April 11, 2014  
NRC list of AREVA Fukushima 3/19/14 Public Meeting Outcomes

# **U.S. EPR – Fukushima Path to Closure**

U.S. EPR Design Certification

Figure 9.4.7-2—Containment Building Low Flow and Full Flow Purge Exhaust Subsystem

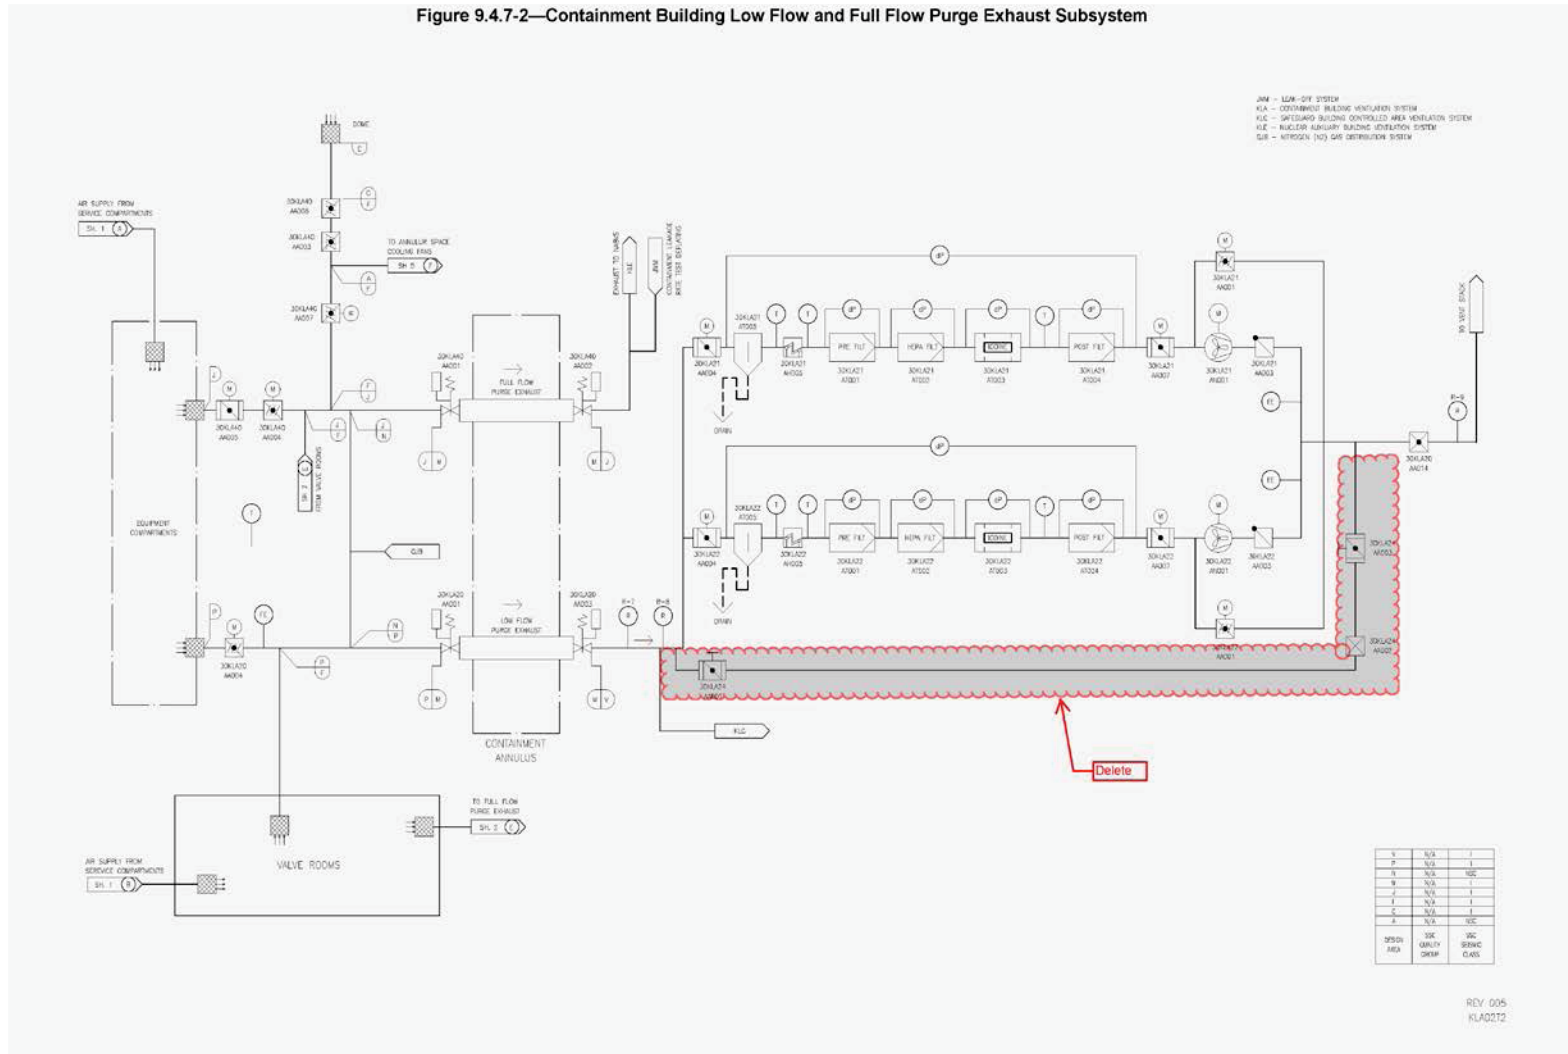
**Change:** Remove Seismic Category I bypass ducting and associated isolation dampers from low flow purge system.

**Rationale:** Resolve NRC questions on viability of containment venting strategy (RAI 598)

# Design condition of check valve on discharge of PCIP

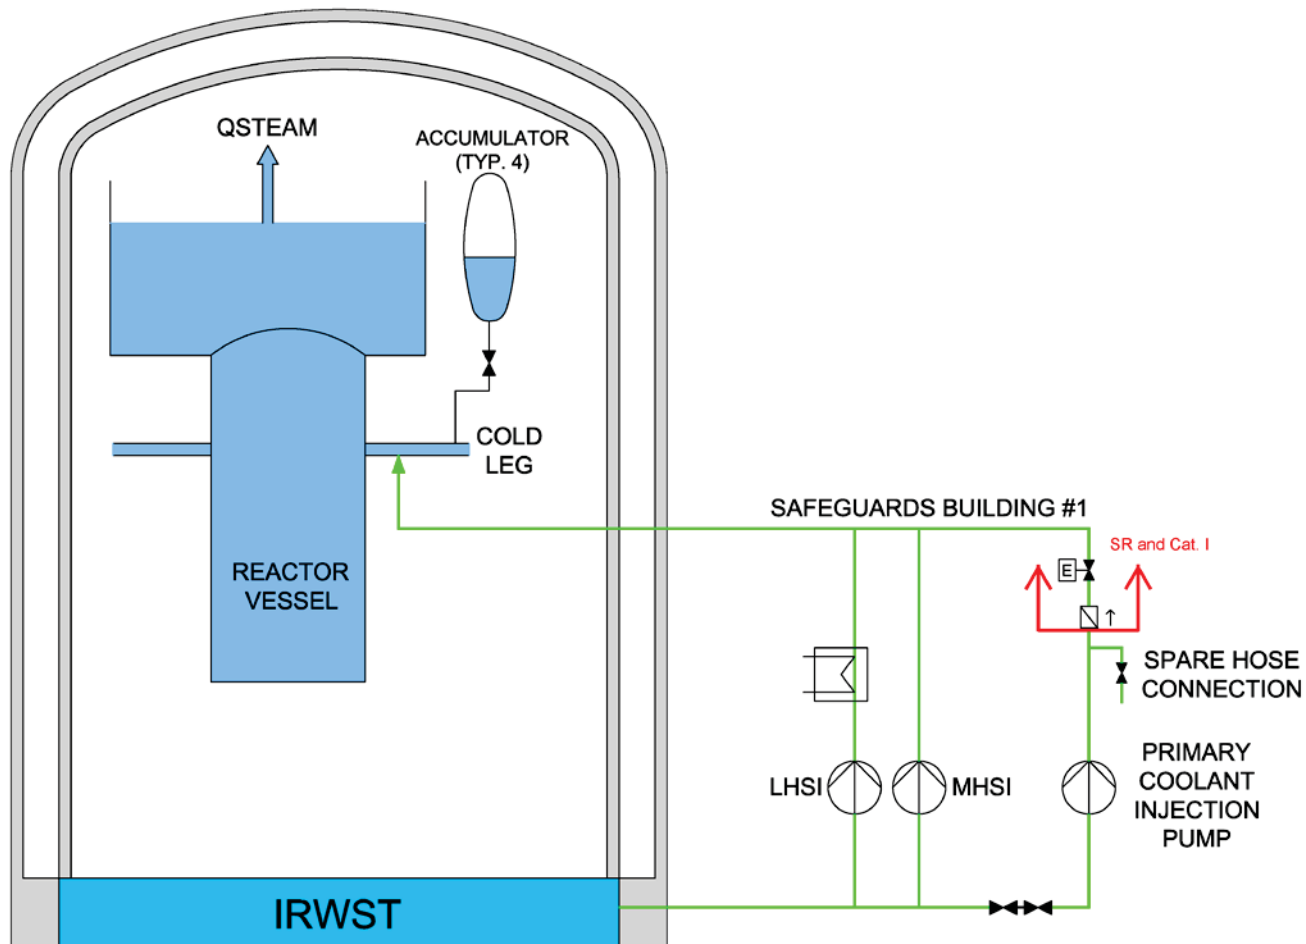
**Change:** Improve single failure protection at discharge of Primary Coolant Injection Pump (PCIP):

- ▶ Move the safety-related, Category I design boundary condition to include check valve 30JND11AA011.
- ▶ Require that 4" motor operated throttling valve (30JND11AA012) be closed and depowered in Modes 1-4

**Rationale:** Resolve Condition Report CR 2013-8207 and RAI 626 to improve single failure protection

Figure 19.2-22—Severe Accident Heat Removal System

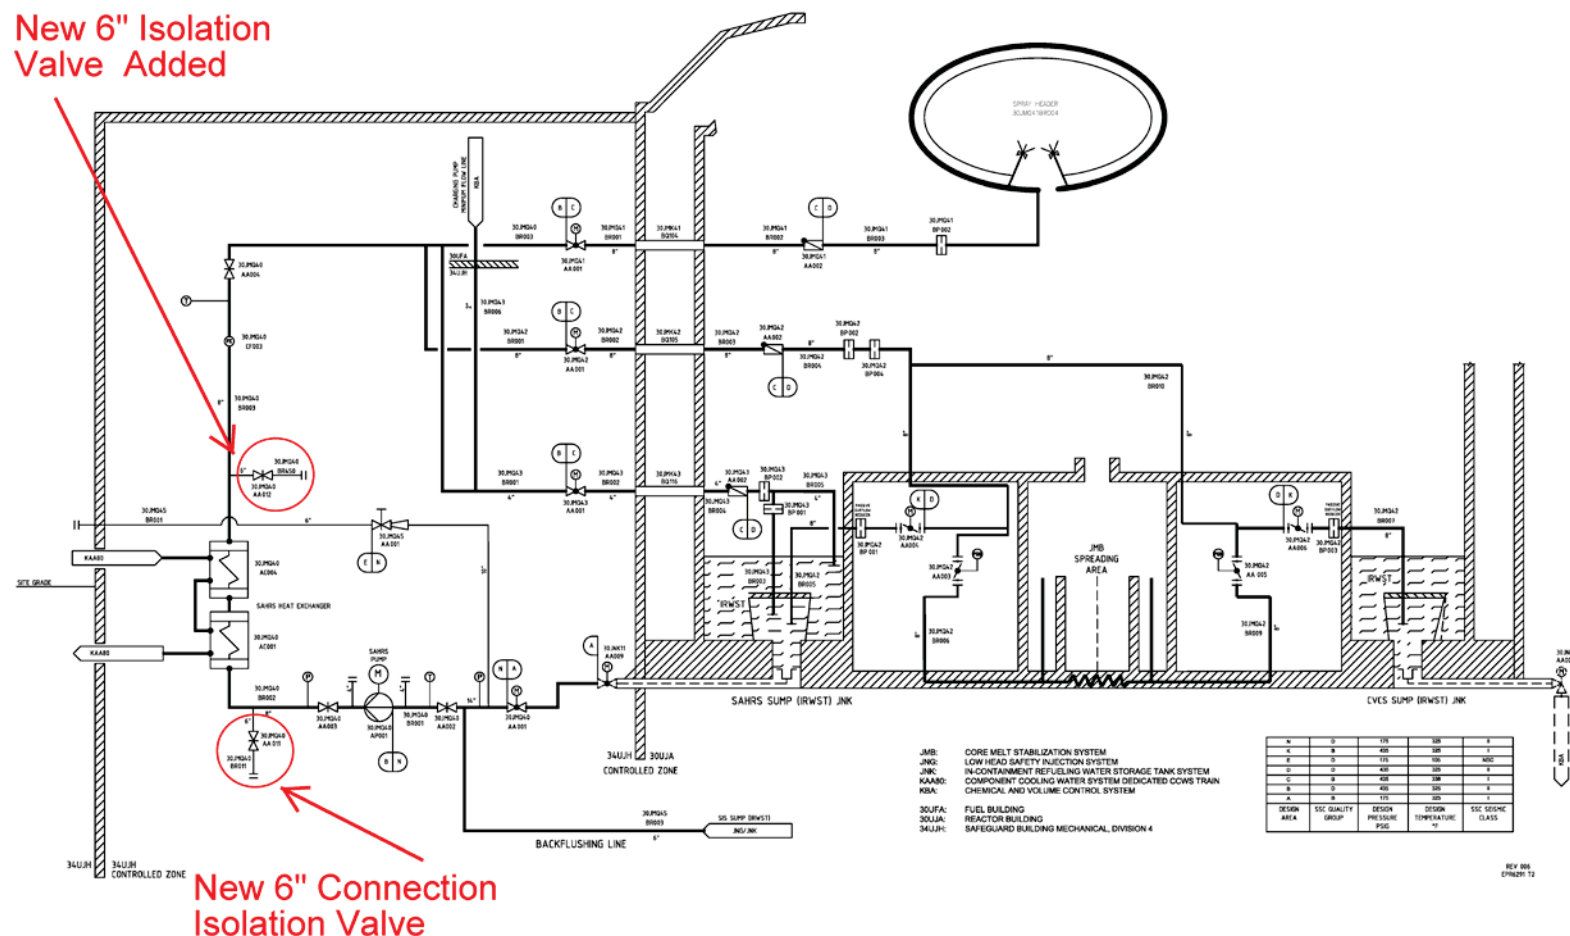
**Change:** Add new connection point to SAHRS and increase size of existing connection point

- ▶ New 6" branch line (30JMQ40BR011) and 6" manual isolation valve 30JMQ40AA011 will be installed downstream of manual isolation valve 30JMQ40AA003.
- ▶ Branch line 30JMQ40BR450 will be increased to 6" and new 6" manual isolation valve 30JMQ40AA012 will be installed at existing flange connection.

**Rationale:** Resolve Condition Report CR 2013-5118 which identified inadequate design conditions of the flange connections on the suction side of the SAHRS Pump for use as a potential connection point for the portable spray pump discharge.

New 6" Isolation Valve Added
